Re: Wastewater Treatment Improvements
City of Greenfield
DNR Project No. S2013-0215A
CWSRF No. CS1920822 01

Subject: Variance Request from 567 IAC 64.2(9a) and Design Standards Section 13.4.2 (Protection against Clogging)

RE: Trash Basket Variance Request
Wastewater Treatment Improvements
Greenfield, Iowa
FOX PN 2390-13A

INFLUENT PUMP STATION
REMOVALS AND MODIFICATIONS
WATERSHED TREATMENT IMPROVEMENTS
CITY OF GREENFIELD
GREENFIELD, IOWA

PROJECT NO.
2390-13A
SHEET
P3

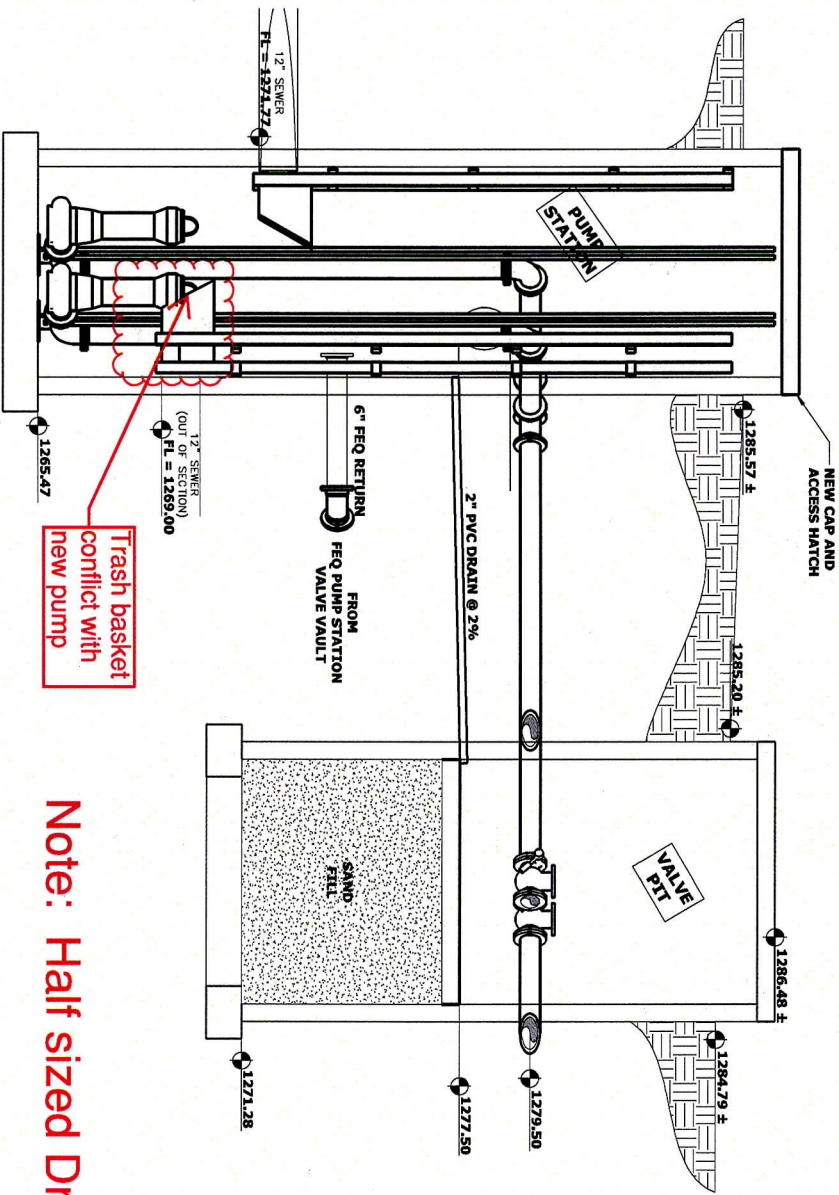
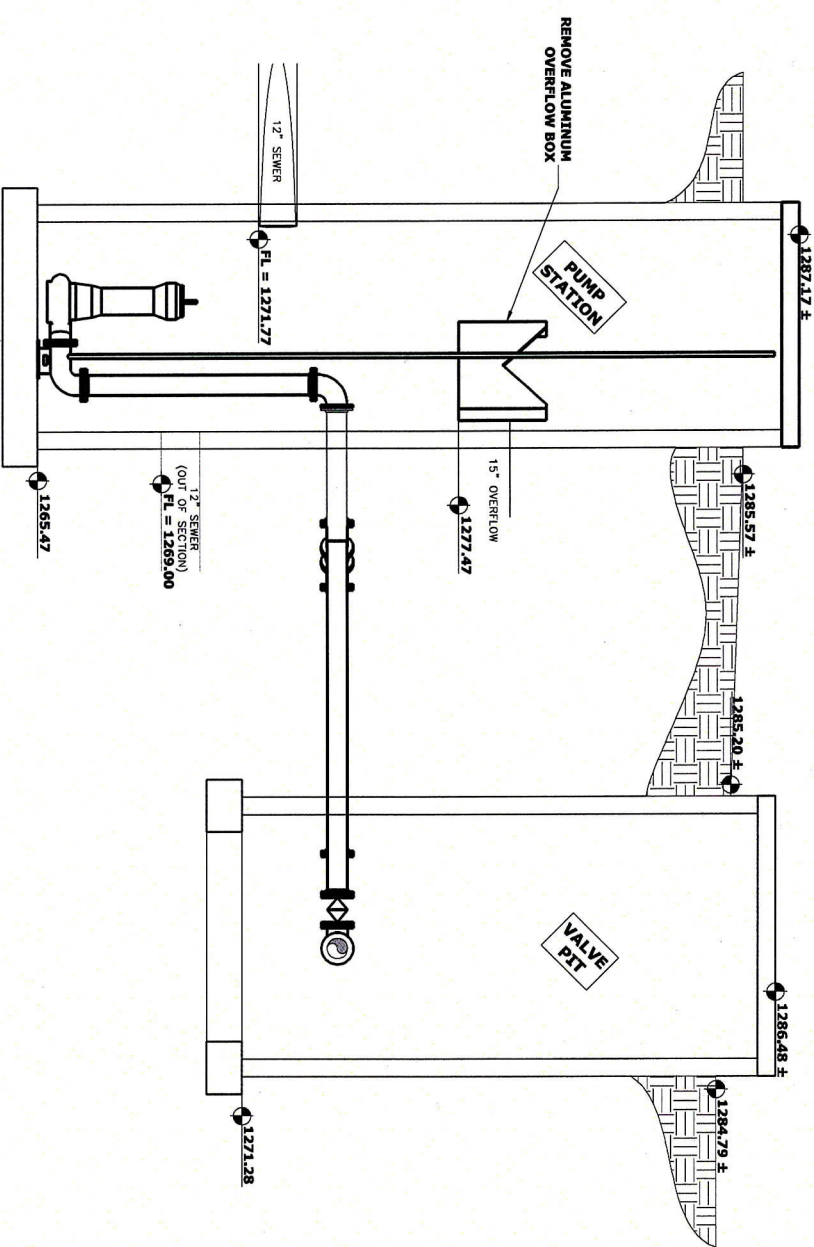
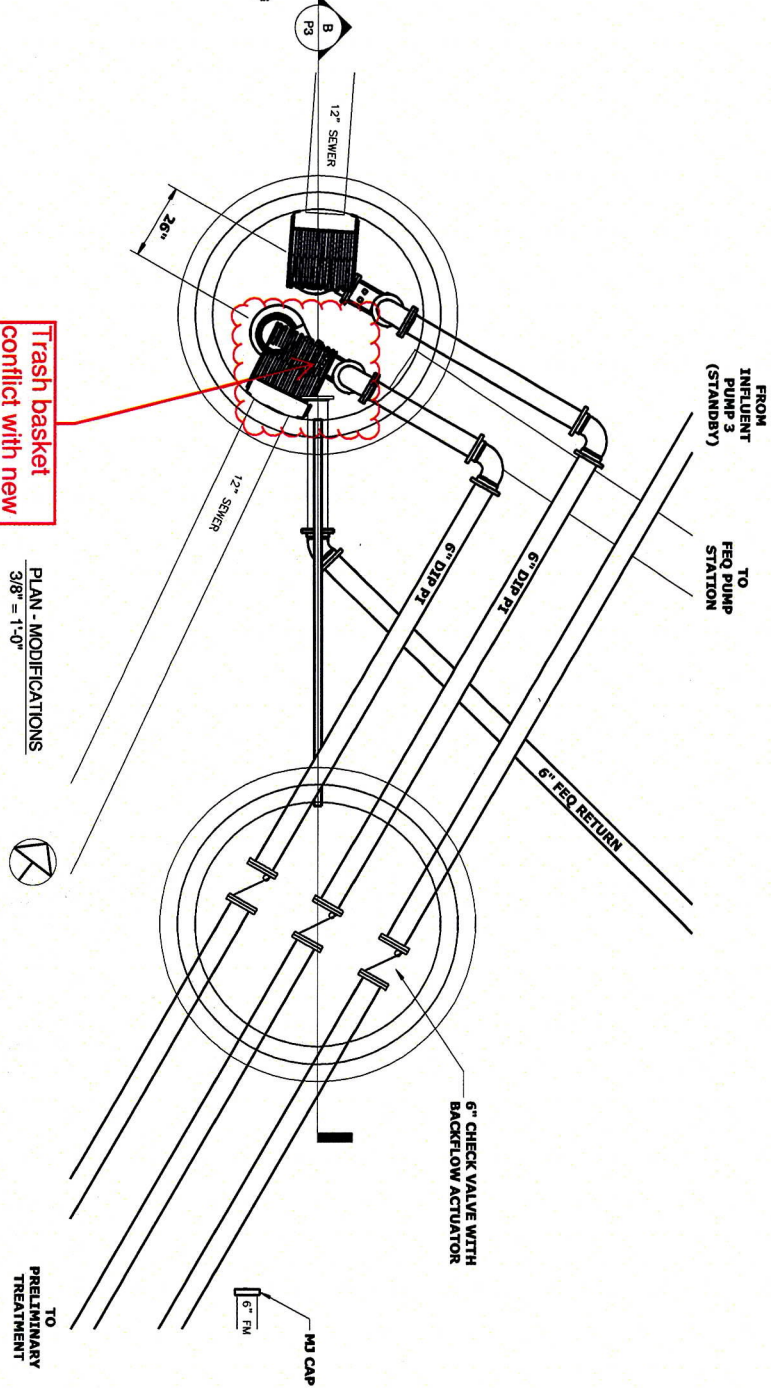
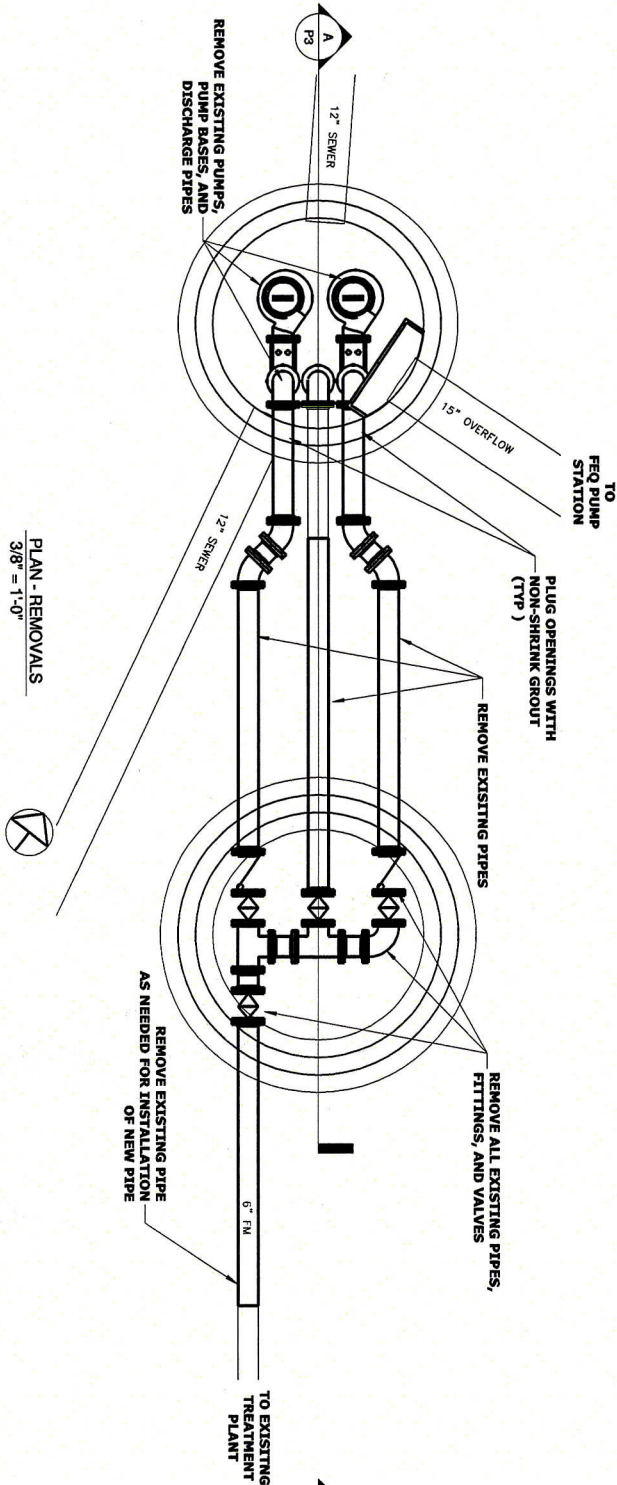
We are currently working on design of a new wastewater treatment plant that will be constructed near the Southeast Lift Station. The scope for this project includes replacement of the pumping systems within the existing Southeast Lift Station wet well structure so that flow will be directed from this pump station to the new treatment plant. In designing these improvements, we have found that it is not feasible to add trash baskets to the existing structure. The existing wet well is only 6 feet in diameter, so there is little room available. There are two 12" sewers that discharge into the existing wet well, so two trash baskets would be needed. One of the two sewers enters the structure only about 3.5 feet from the bottom of the wet well, and it is anticipated that a trash basket on this sewer would conflict with one of the pumps.

1. None of the existing pump stations in Greenfield are equipped with trash baskets, and all three have performed adequately.
2. It is not feasible to add trash baskets to the existing Southeast Lift Station due to lack of physical space in the structure. Adding a new structure would be extremely cost prohibitive and undesirable.

This variance is approved for the Southeast Pump Station only. We agree that retrofit of the existing pump station presents unique circumstances that make installation of a conventional trash basket difficult. Other factors included in our determination supporting approval of this variance were 10-States Standards does not require it and the existing pump station has operated for a significant time period (30 years) without any screening protection or incidences of pump clogging. However, since the prior successful operation of the existing pump station without screening protection does not necessarily guarantee that future pump clogging without a trash basket will not occur, the following condition will be included in the construction permit issued for the project:

If in the future any bypassing should occur at the Southeast Pump Station that is attributable to clogging of the pumps, the City shall take any necessary steps required to install screening protection for this pump station.
